## SERVICE BULLETIN

### No. SB-300-2-97

**Subject:** Fuselage structure / tail spring support

**Aircraft affected:** Following models and SN  
EA-300/L: S/N 01-170, 172, 173 and  
1171, 1174-1299

*Figure 1: Possible crack locations in the area of tail gear spring attachment (retrofit plates of SB-300-2-97 issue A installed)*

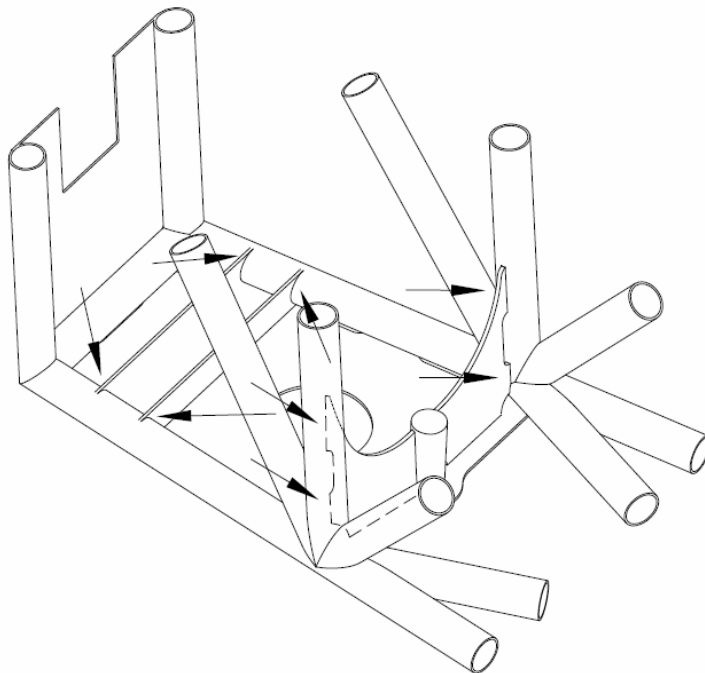
- Remove elevator control inspection window
- Visual inspection of tail spring mounting along welds to fuselage tubing. Cracks have been reported at the spots marked in figure 1. Investigate these areas carefully. To assist the visual inspection it is helpful to use a torchlight and a magnifying glass.
- In case cracks are found proceed with the instructions of PART II.
- In case no cracks are found reinstall elevator control inspection window and make appropriate entry of compliance in aircraft logbook.

*Figure 2: Removing the fabric*

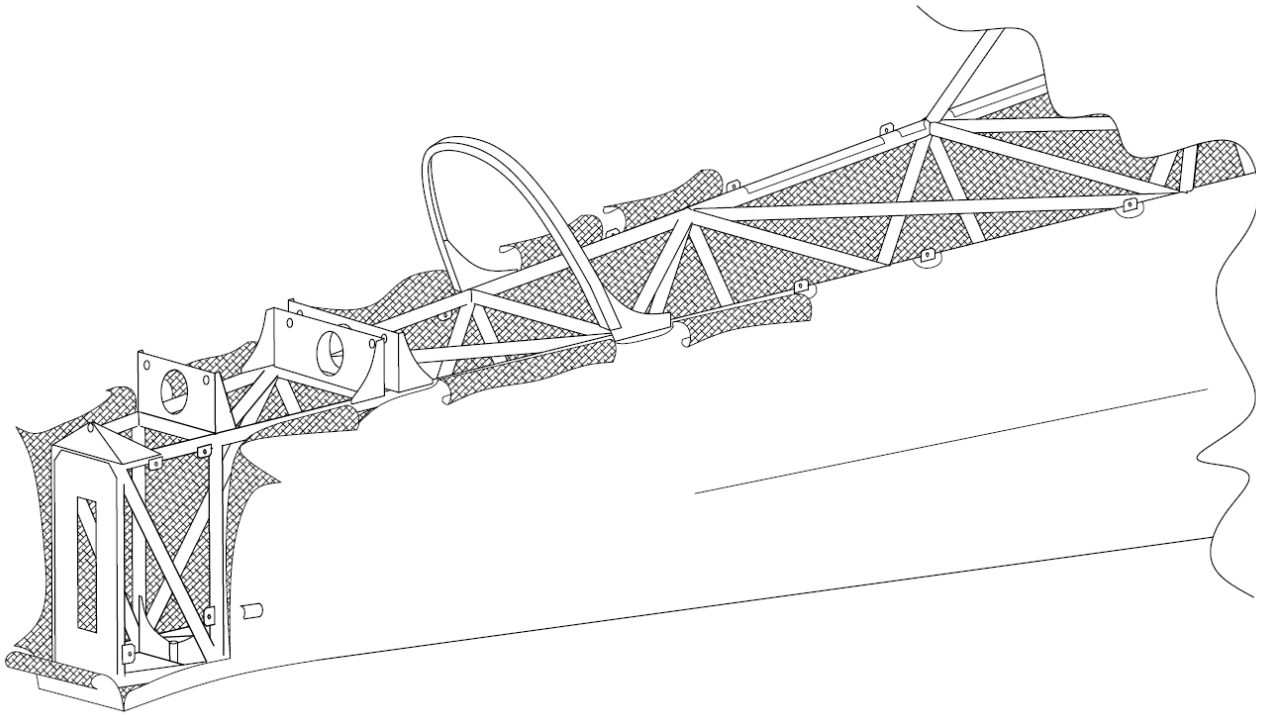
- Remove tail spring assembly, according Chapter 32 of the Service Manual.
- Disconnect battery ground wire and engine ground wire to firewall.
- Peel off fabric from upper L/H and R/H longeron, from rear facing fuselage surface and R/H lower longeron in the area of the inspection window (refer to figure 2 for detailed sketch). Do not use sharp objects that could damage the fabric while peeling it off. Fold the fabric far enough forward to have sufficient access to the area for welding. Make sure to work gently in order not to introduce cracks in the fabric paint coat finish.

*Figure 3: Cutout for crack repair and retrofit*

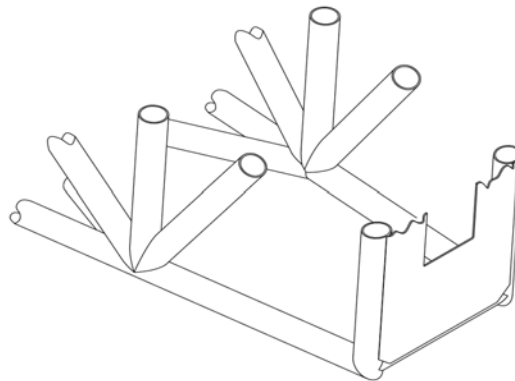
- Cut out tail spring mounting plate including front and rear stiffener (figure 3 shows detail of rear truss after cutting). Proceed with caution. Avoid damaging any truss tubes (except those tubes that are replaced).

Figure 4: Method of inner sleeve splicing, recommended for tubing crack repair  
(ref. AC 43-13-1B, Aircraft Inspection and Repair, Chapter 04)

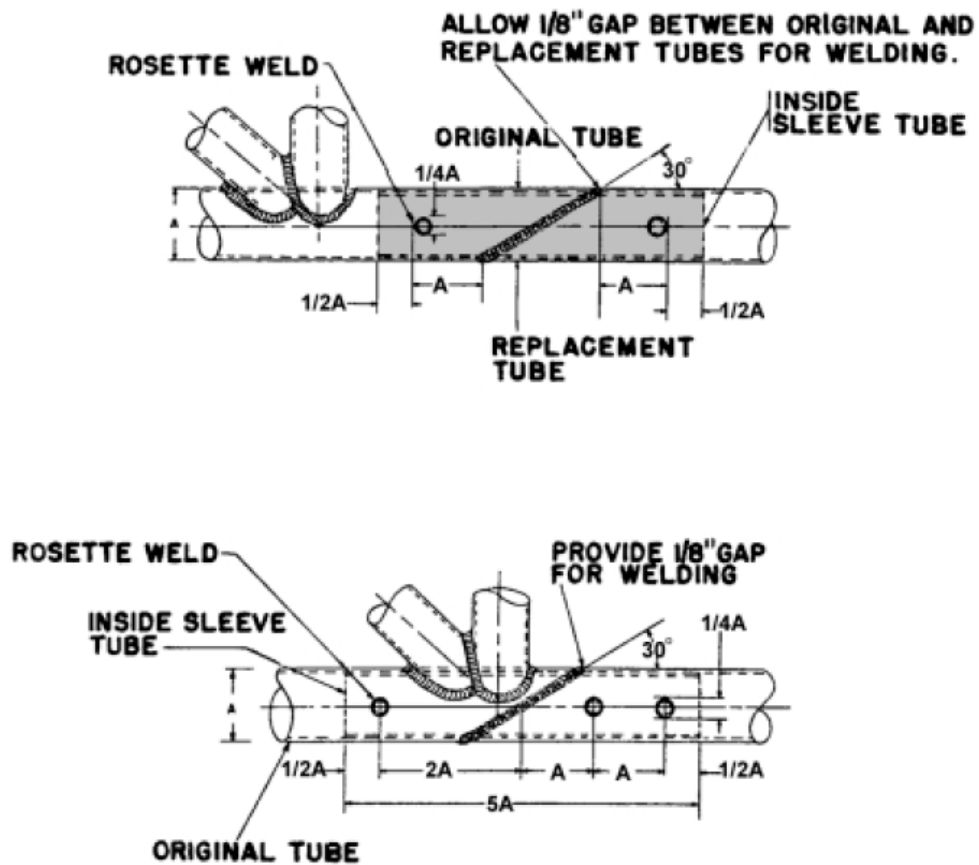
- Repair any cracks found. Refer to Chapter 51-70-05 "Structural Repair of Steel Components" of the Service Manual and figure 4.
- Weld retrofit plates in place, refer to figure 5 for correct position of plates and welds.
